TITLE	PARTIAL MEZZANINE/LOW ROOF FRAMING PLAN - AREA B (SEQ-1)		
MADE BY	DATE	CONTRACTOR	JOB No.
PDS	11/30/2020		20028
CHKD BY	DATE	ARCHITECT	ENGINEER
JSY	11/30/2020		
			SHEET NO.
			1E1
			REV.
			A

**PARTIAL MEZZANINE/LOW ROOF FRAMING PLAN @ AREA-B (SEQ-1)**  
 (REF: S2.2 & 1/A1.3)  
 [TOP OF STEEL ELEVATION 114'-0 1/2" U.N.O.]

TITLE		BRACE ELEVATIONS @ AREA-B		JOB No.	
MADE BY	DATE	CONTRACTOR		20028	
CHKD BY	DATE	ARCHITECT	ENGINEER	SHEET NO.	REV.
JSY	11/30/2020			1E9	A

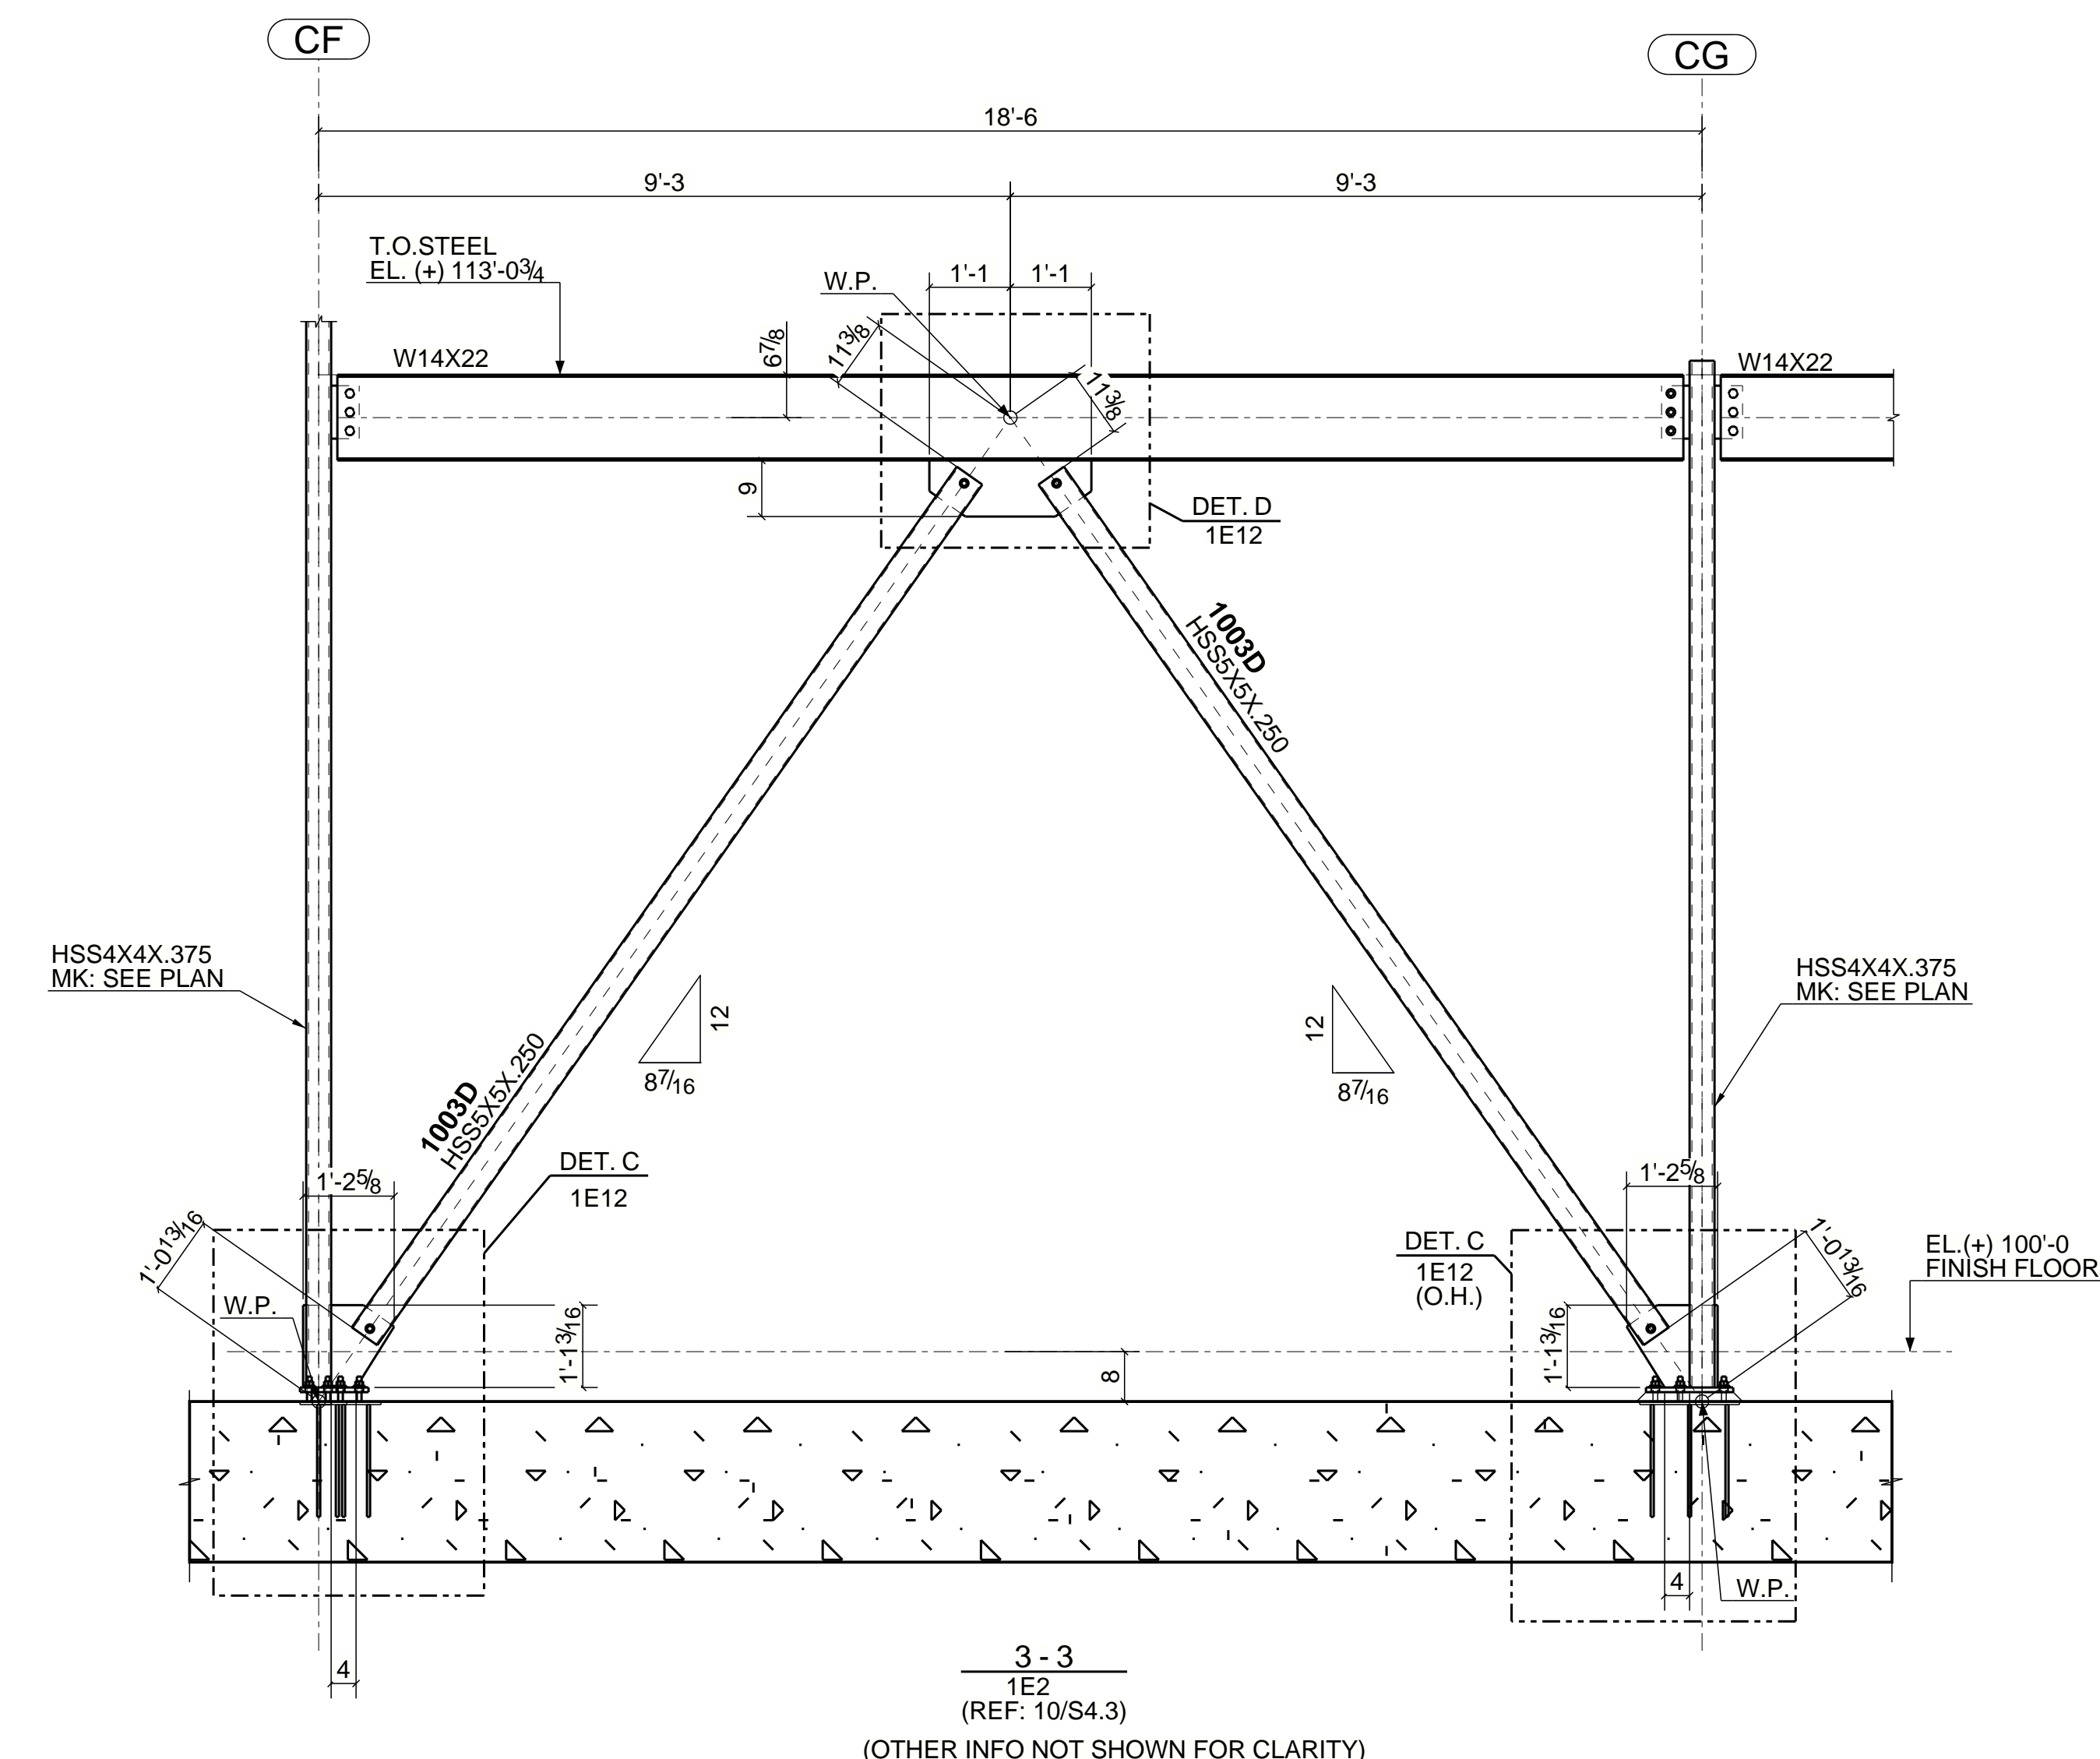
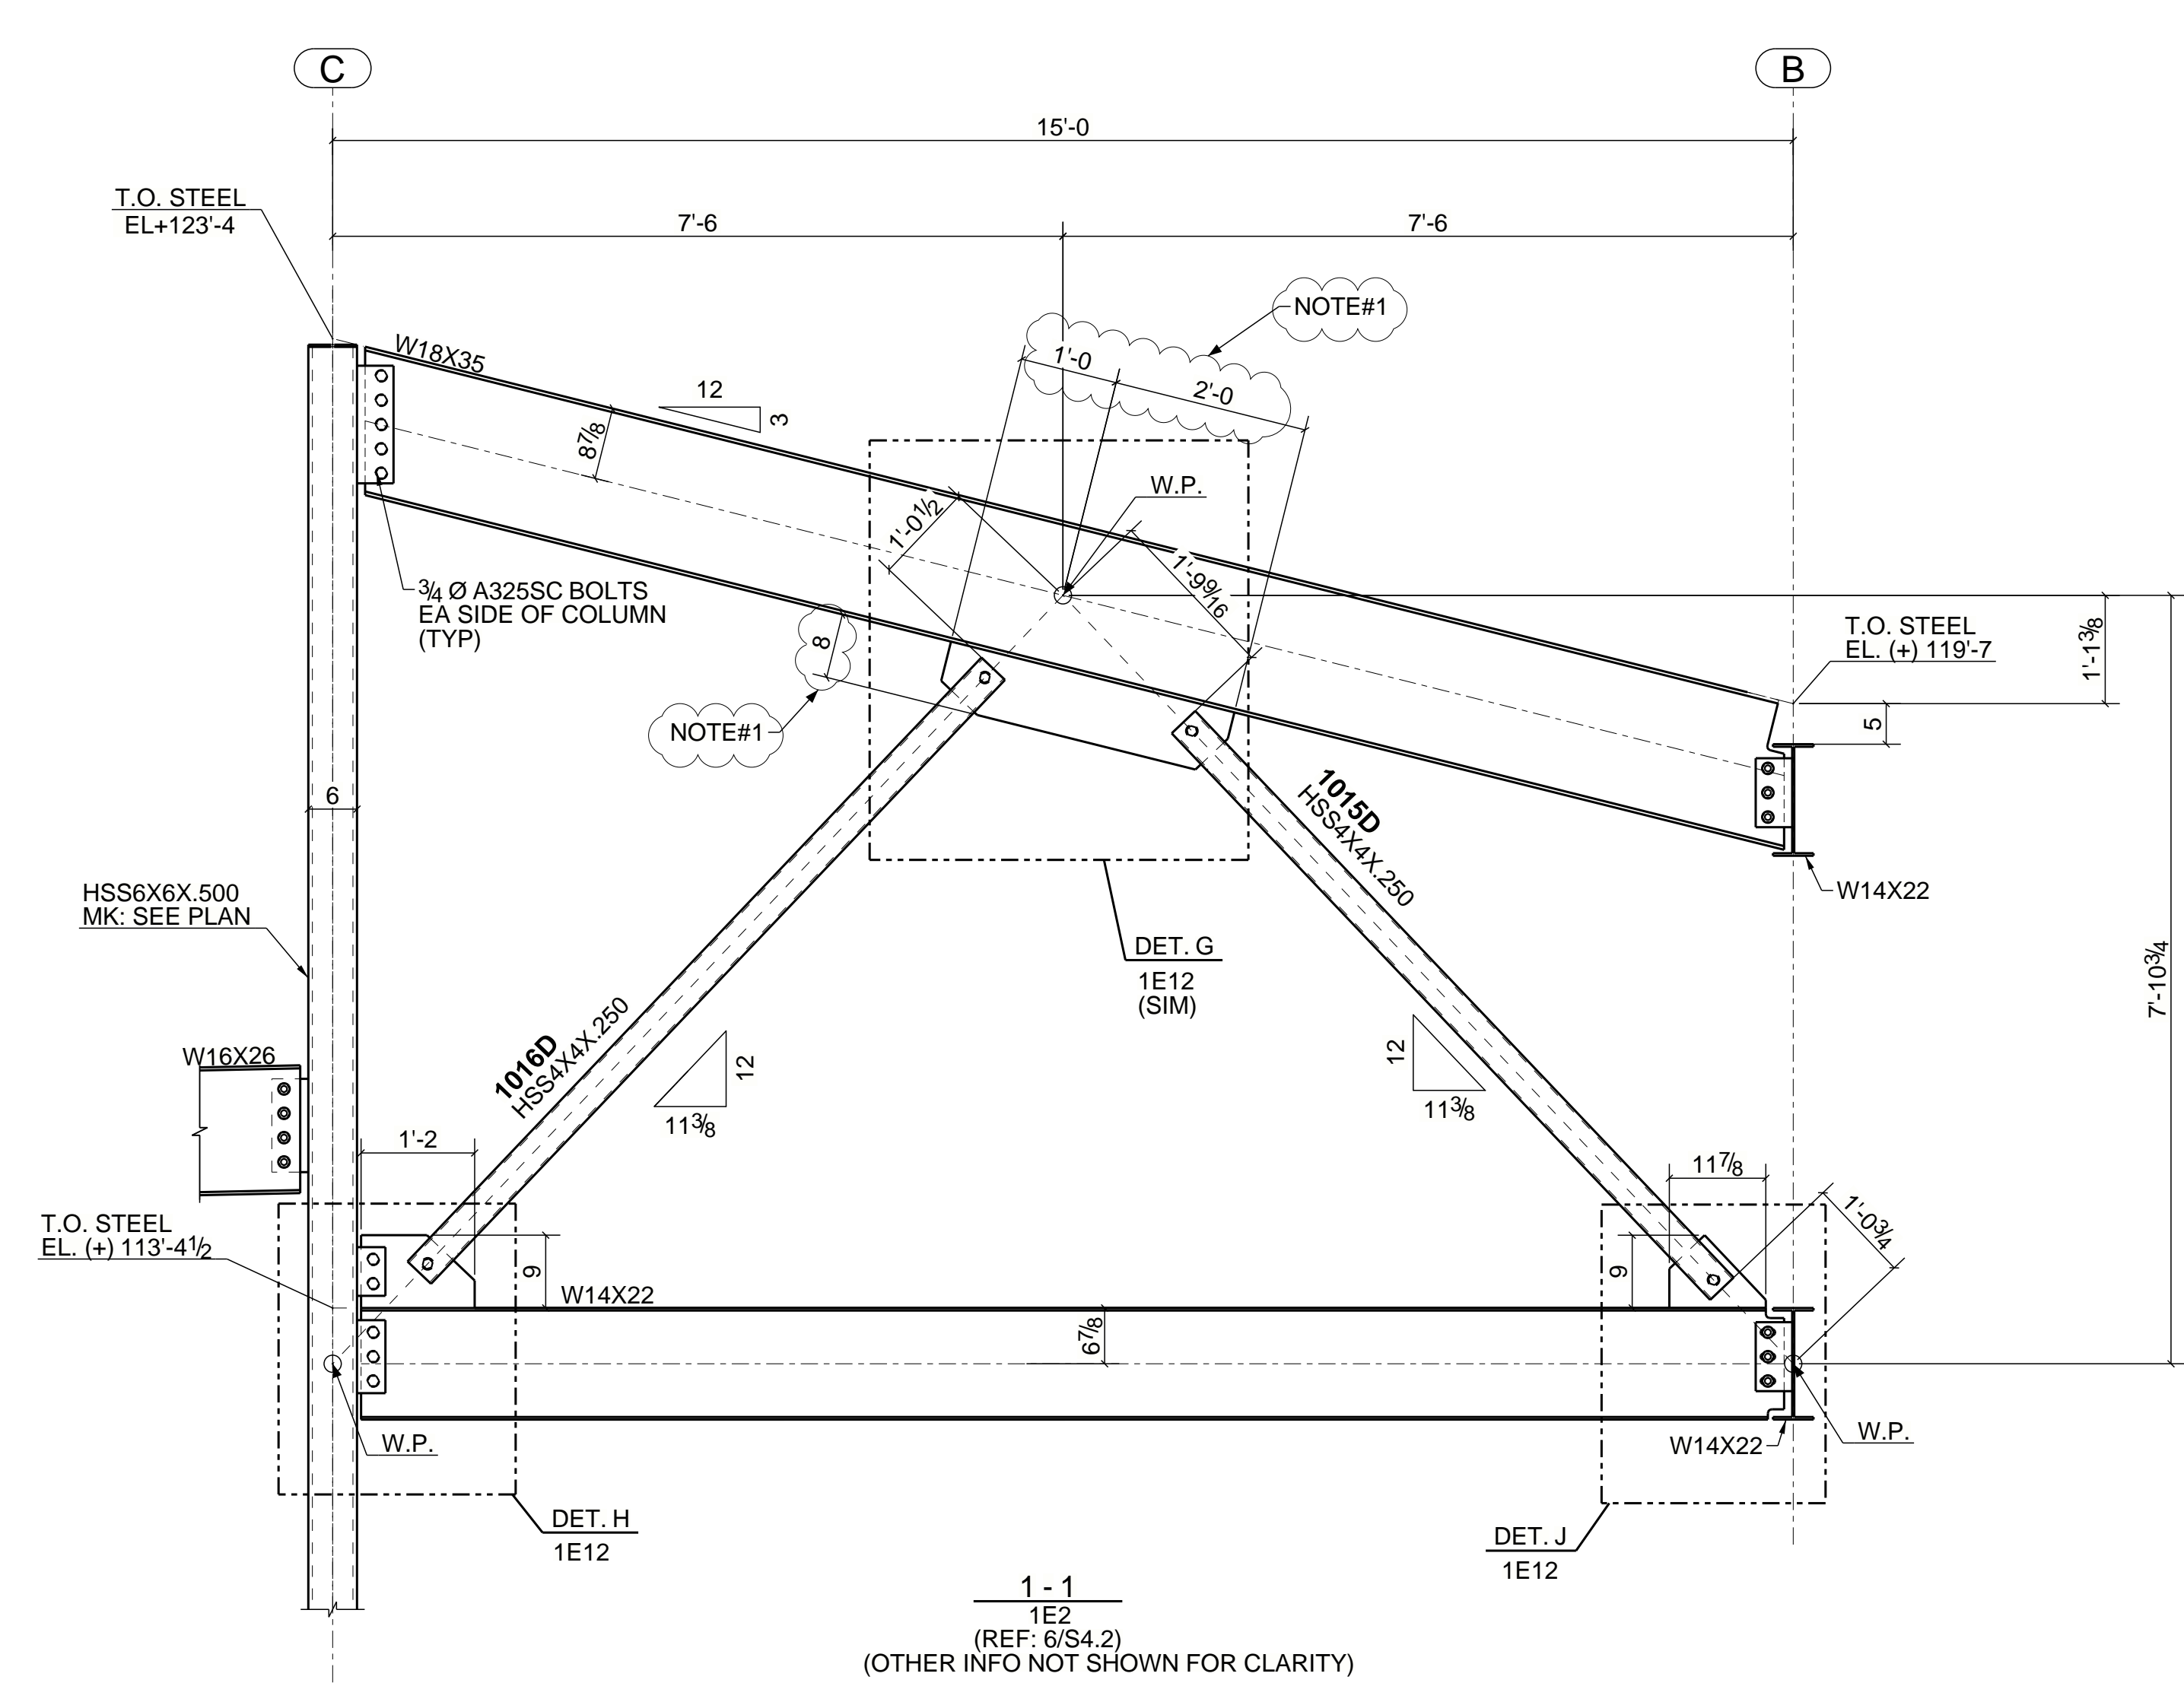
**APPROVER NOTE:-**  
 NOTE#1:- REFER STRU DRAWING S4.2. BRACE DETAIL 6/S4.2 SHOWS CONNECTION TYPE "20C". BUT WE HAVE FOLLOWED CONNECTION TYPE "20F" SIMILAR TO BRACE DETAIL 1&2/S4.2. PLEASE VERIFY/CONFIRM.

TITLE	ROOF SECTIONS @ AREA B		
MADE BY	DATE	CONTRACTOR	JOB No.
PDS	11/30/2020		20028
CHKD BY	DATE	ARCHITECT	ENGINEER
JSY	11/30/2020		
			SHEET NO.
			1E13
			REV.
			A

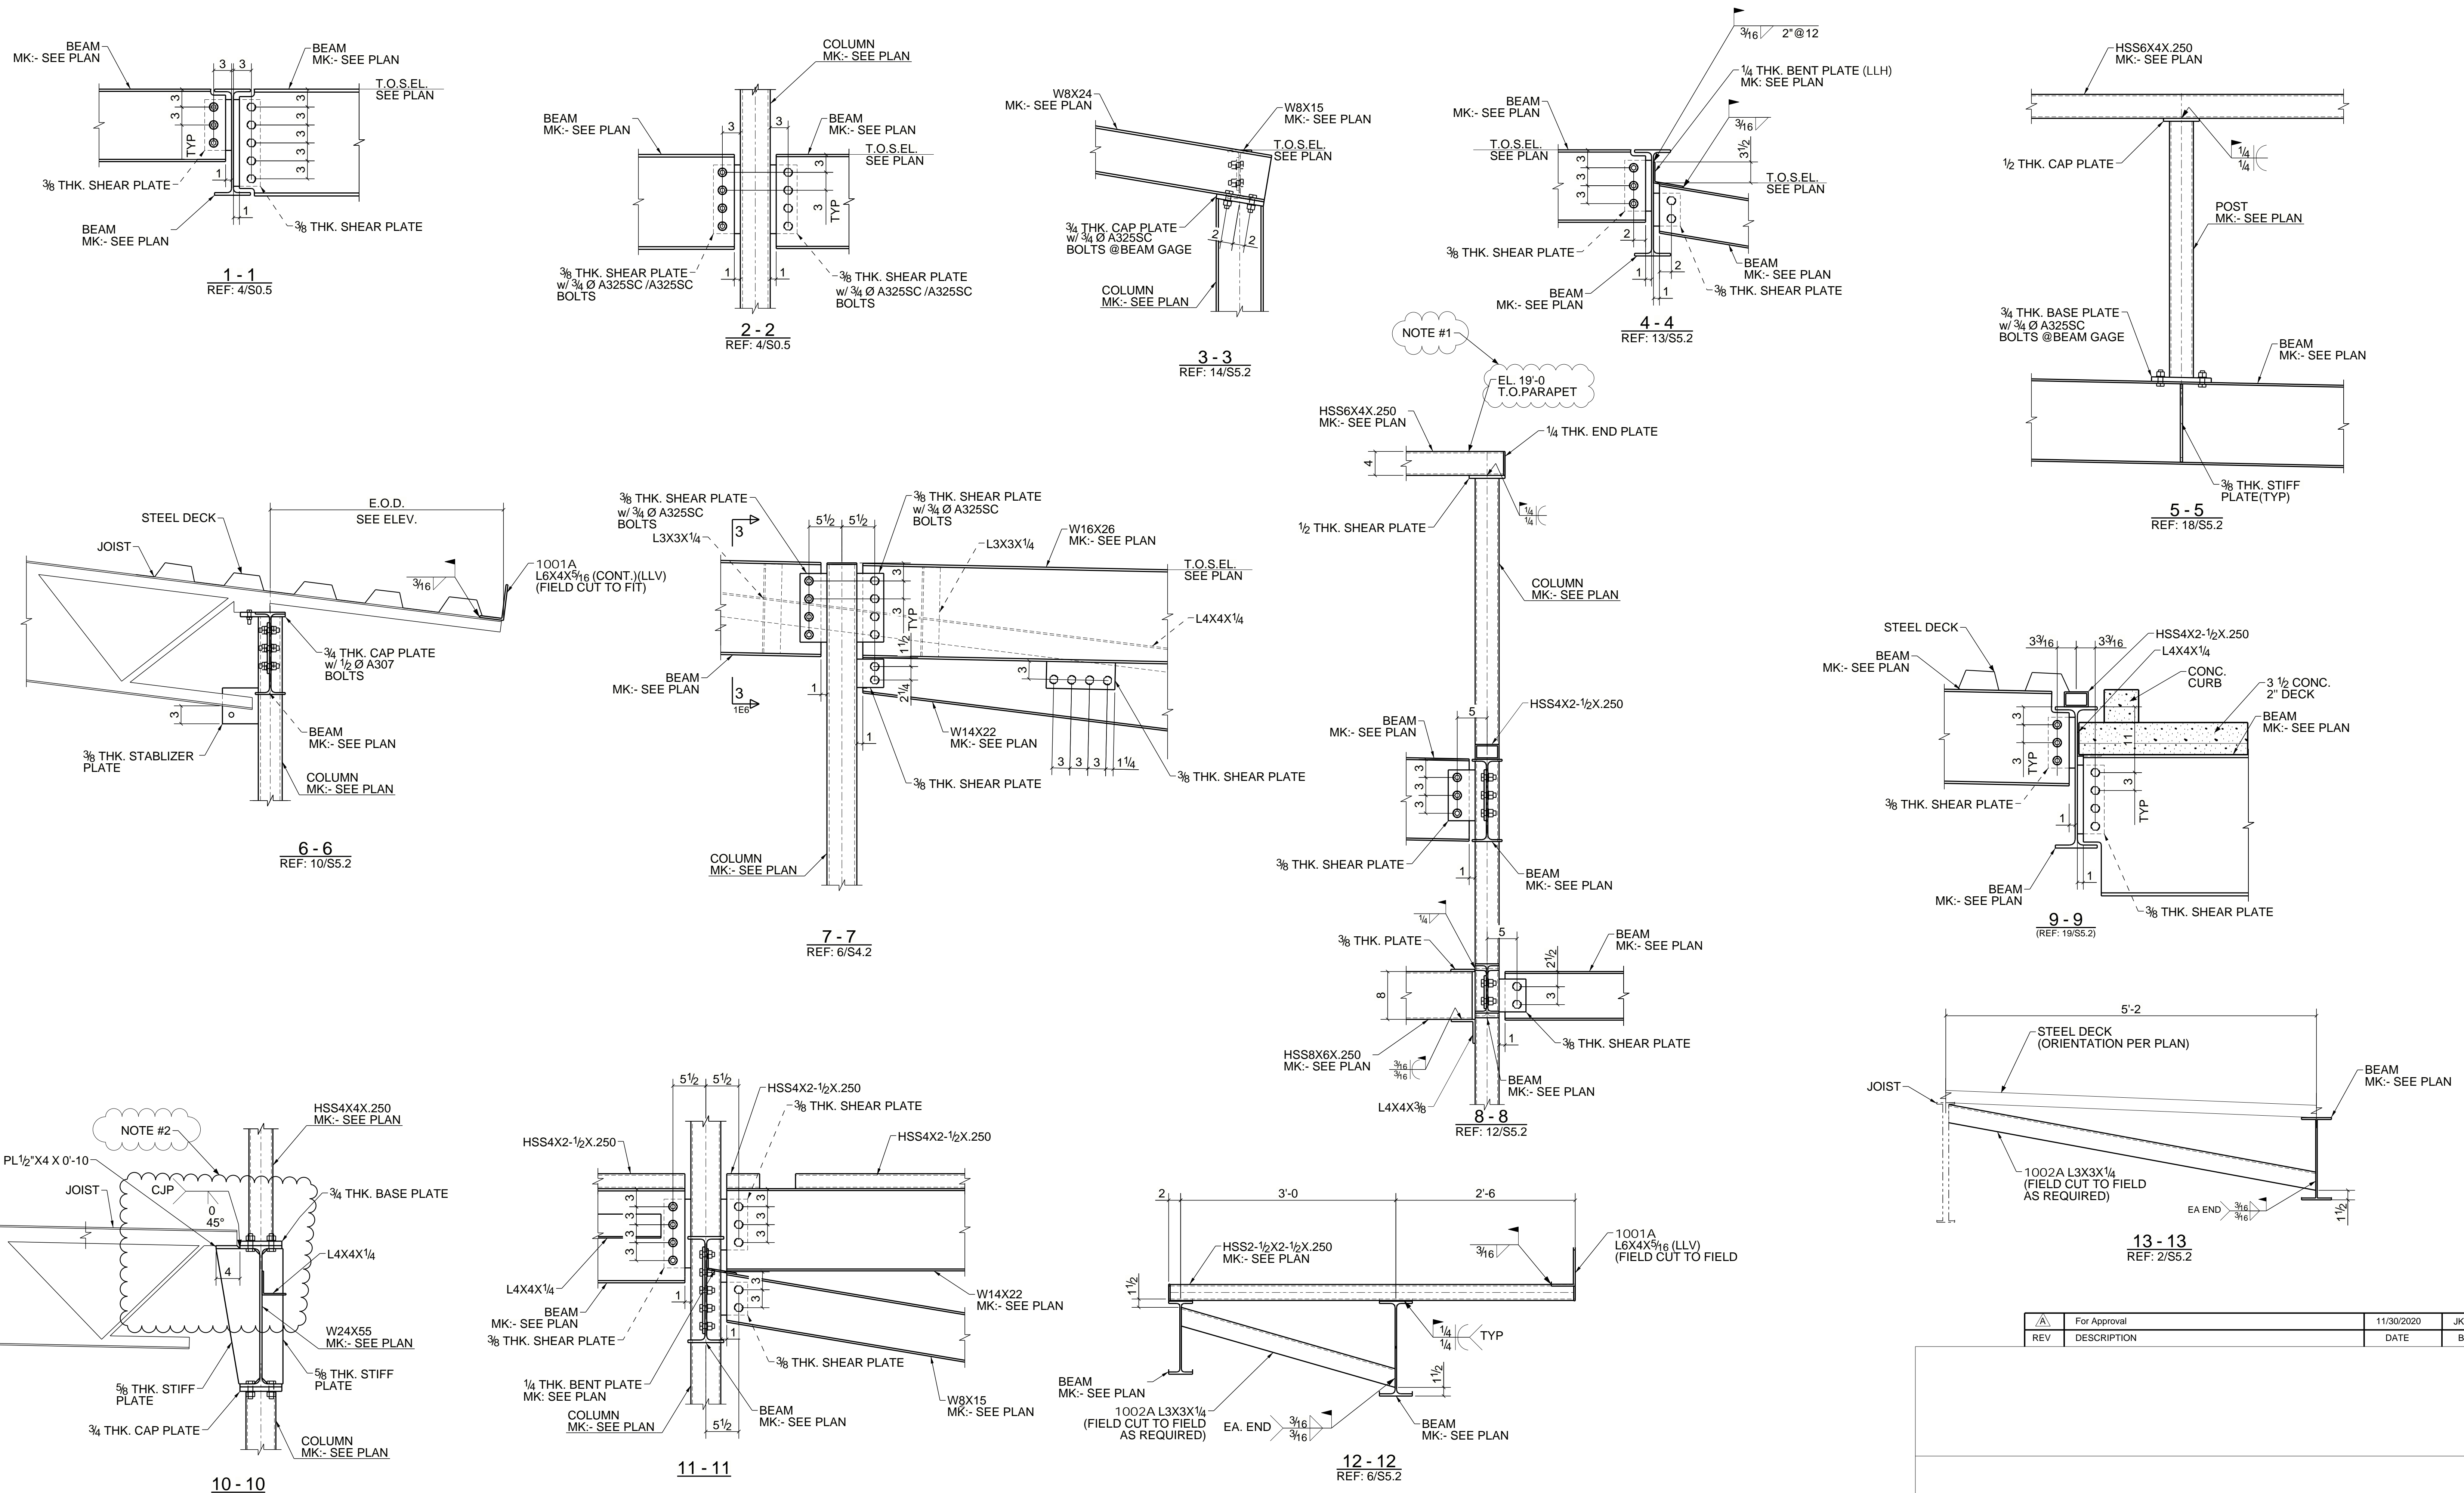
**APPROVER NOTES:-**  
 NOTE #1:- PLEASE VERIFY/PROVIDE TOP OF PARAPET ELEVATION.  
 NOTE #2:- PLEASE VERIFY/PROVIDE JOIST TO BEAM CONNECTION ARRANGEMENT AT WHERE JOIST IS OCCURRING ALIGN TO ABOVE COLUMN LINE.
